IN THE DRAWINGS:

REMARKS

Serial No.: 10/824,574
Docket No.: 3089-6391US
REPLACEMENT SHEET

Fig. 4

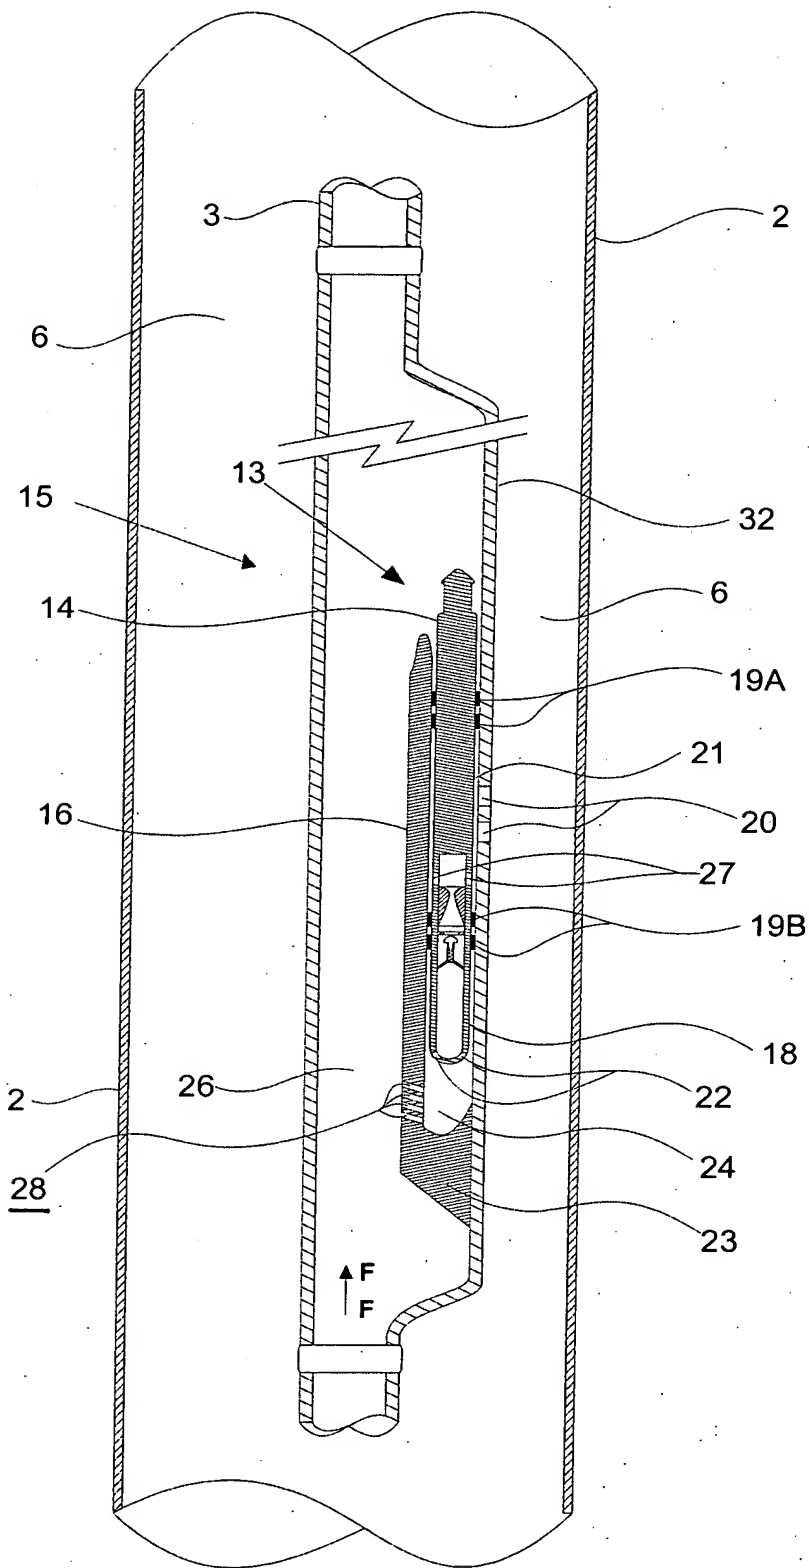
With regard to the objection to the plurality of tangential injection orifices, applicant respectfully submits that these orifices are illustrated in amended Fig. 4 and are identified by the reference number "28" in that amended drawing Figure.

Claims 4-11 are rejected under 35 USC 112. Claims 8-11 have been cancelled thereby rendering their rejection moot. With reference to the issue of the reference number "28," applicant has amended Fig. 4 of the drawings by deleting the reference number "50" and substituting "28" therefore. It is respectfully submitted that with this amendment, any issue of indefiniteness associated with the indication of the reference number "28" in claims 4, 5, 6 and 7 has been obviated. Applicant has also amended claim 7 to remove the number "4" therefrom thereby addressing the Examiner's concern in this regard. The Examiner's concerns regarding

The attached sheets of drawings include changes to FIGS. 2, 4 and 5. These sheets, which include FIGS. 2, 5 and 5 replace the original sheets including FIGS. 2, 4, and 5. FIG 2 has been amended to include the wording "PRIOR ART". FIG. 4 has been amended by substituting the reference number "28" for the reference number "50". FIG. 5 has been amended by insertion of the reference number "29." No new matter has been added.

With reference to the Examiner's comments in paragraph 3 of the Action, applicant has amended the drawing figures by substituting the reference number "28" for the reference number "50" thereby conforming the drawings to the specification. Similarly, paragraph [00125] has been amended to replace the reference number "26" with the reference number "28" to make this
